SUBJECT:
FURNISHING ADDL INFO TO APPLICANT'S PROPOSED TECH SPEC CHANGE REQUEST NO 70A,
CONSISTING OF TECH SPEC PAGES SPECIFIC TO CYCLE 3, THAT WERE INADVERTENTLY
OMITTED FROM APPLICANT'S CYCLE 4 SUBMITTAL, AND FURNISHING JUSTIFICATION FOR
THESE CHANGES ... W/ATT 1

PLANT NAME: THREE MILE ISLAND - UNIT 1

Three Mile Island Nuclear Station, Unit 1 (TMI-1)
Operating License No. DPR-50
Docket No. 50-289
Technical Specification Change Request No. 70A
(Additional Information)

Figure 2.1-3

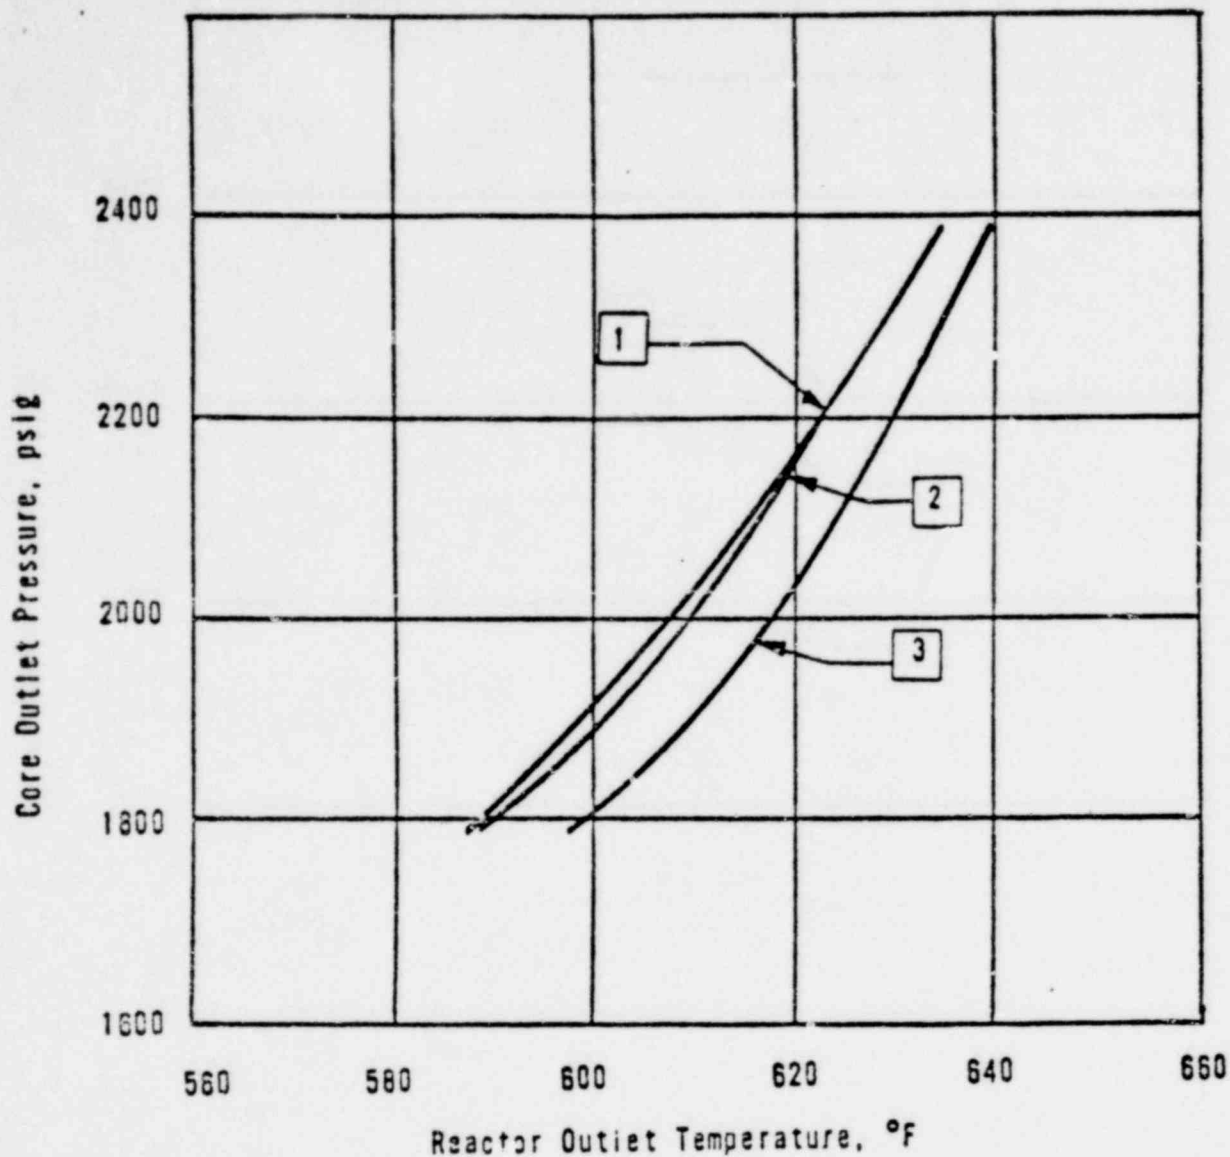
The power levels for Curves 2 and 3 of Figure 2.1-3 of the TMI-1 Cycle 4 Technical Specifications should be consistent. These power levels differ from those reported for Cycle 3 by the setpoint adjustment error which is a necessary component of the calibration and instrumentation errors. The correct Cycle 4 values for the power levels of the aforementioned Curves 2 and 3 are 87.1% and 59.6% respectively. Figure 2.1-3 has been revised to reflect these values. There is no reduction in the safety margin as a result of these changes.

Figure 2.1-1

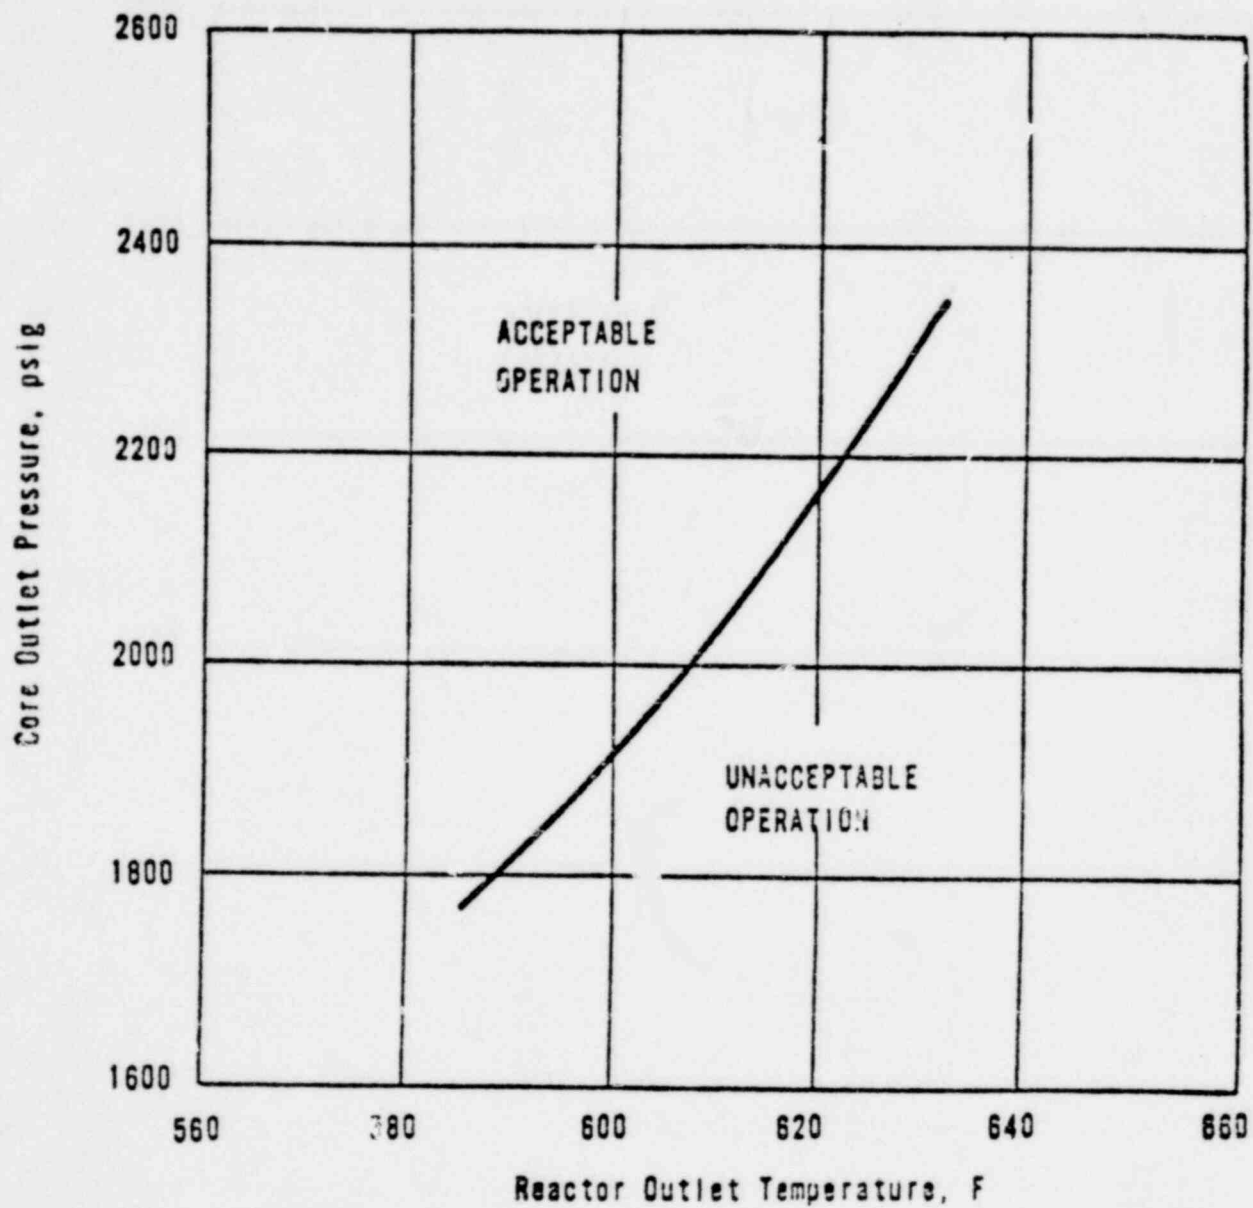
Section 6 of the Cycle 4 Reload Report submitted in support of Tech. Spec. Change Request No. 70, states that the only difference between cycles 3 and 4 is the core configuration. For Cycle 4, the addition of the higher flow resistance Mark B2 and B3 assemblies provides additional DNBR margin over Cycle 3 due to increased flow through the limiting Mark B4 assembly.

Additional conservatism for Cycle 4 operation is provided by the reduced peaking factors. The minimum DNBR calculated from the Cycle 2 analysis (the Cycle 2 DNBR analysis was used for reference Cycle 3) is based

on a radial-local peak of 1.783. The maximum radial-local peak calculated for Cycle 4 operation (287.1 EFPD Cycle 3 and Non-cross core shuffle), including 8% nuclear uncertainty, is 1.547 at BOC. This decreases to 1.403 at the end of Cycle 4. This provides a 13.2% margin to the design peak at ROC and a 21.3% margin at EOC.

Figure 2.1-1, unchanged for Cycle 4, represents a more conservative limit and does not result in a reduced safety margin.

Figure 2.3-1

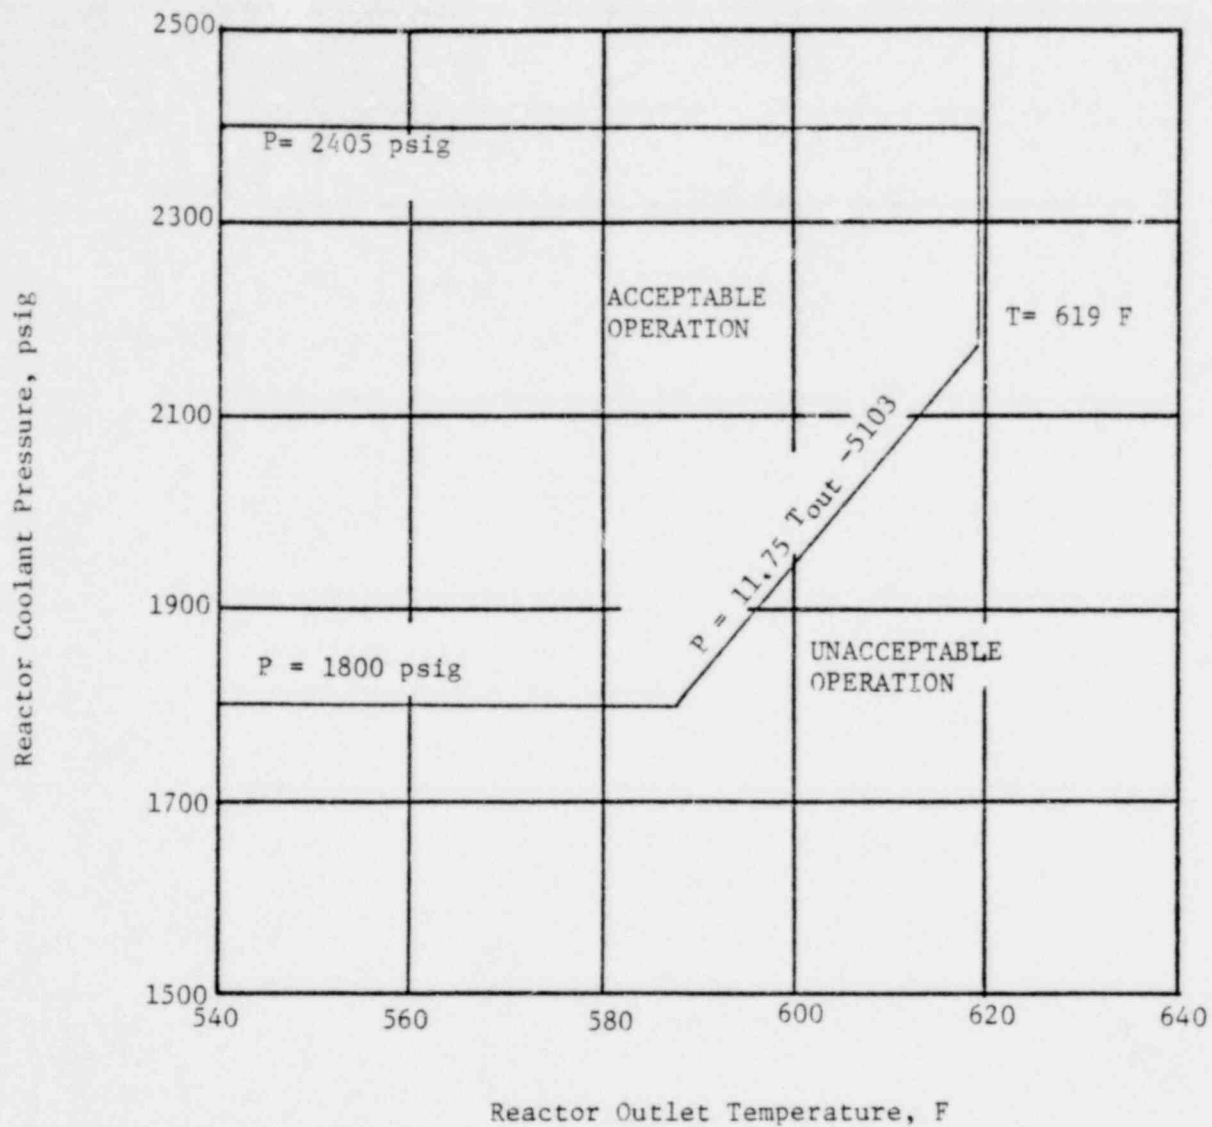
A bounding analysis, showing peak RC system pressure vs. moderator coefficients and a conservative doppler coefficient for the feedwater line break accident, has been performed to justify the high pressure trip setpoint of 2405 psig and the corresponding 2500 psig pressurizer code safety valve settings. Results of this analysis were submitted to NRC on April 17, 1978, (GQL 0669), and supplemented on April 20, 1978 (GQL 0743). Since the Cycle 4 parameters are bounded by the analysis, and the 2750 psig peak pressure limit is not exceeded, there is no reduction in safety margin and no resulting threat to the health and safety of the public.
